FIELD SERVICE BULLETIN

FSB Number: LVCCFSB2004-63
Author: Tony Bryan
Date: March 31st, 2004
Total No. of Pages: 2
Subject: **GSM V600 - CLI Lens**
Model Affected: GSM V600
Level of Repair: 2

Diagram 1.0 - V600 CLI Lens with micro cracking at hinge

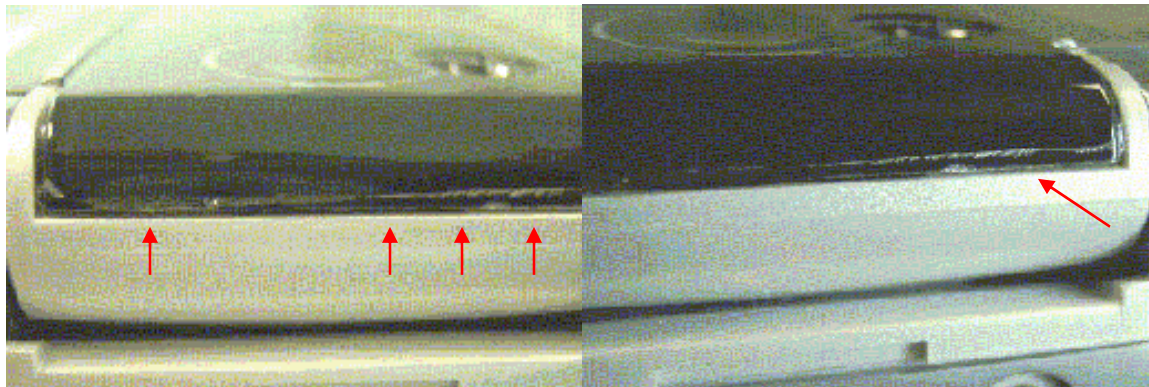
Service is aware of an issue affecting some CLI Lenses (6187309Y01/Y02/Y03) on GSM V600, shipped to EMEA during the months of December 2003 through March 2004. The affected lenses start to show a visible cosmetic defect, micro cracking at the hinge, after periods of use. The cracks originate at the top-left edge of the lens and propagate along the edges thru part mid-plane. See Diagram 1.0 below for an example of this defect. Analysis has revealed the cracking to be caused by molded-in stresses, which manifest after time and stabilize once the stresses have been relieved. The root cause of the molded-in stresses is related to process timing issue at the supplier between the filling of the mold and the IMD Decoration process.

Corrective Action (3/10/04): An annealing process has been implemented at both lens suppliers to relieve molded-in stresses. Annealing process consist of baking the lens in an oven for a time period determined by the cycle-time of the suppliers' molding processes. Engineering is evaluating a material change for the lens to Acrylic.

1. Visually inspect the CLI Lens for the defect detailed in Diagram 1.0 above
2. Replace the CLI Lens if needed. Refer to the V600 CLI Lens Replacement Procedure.
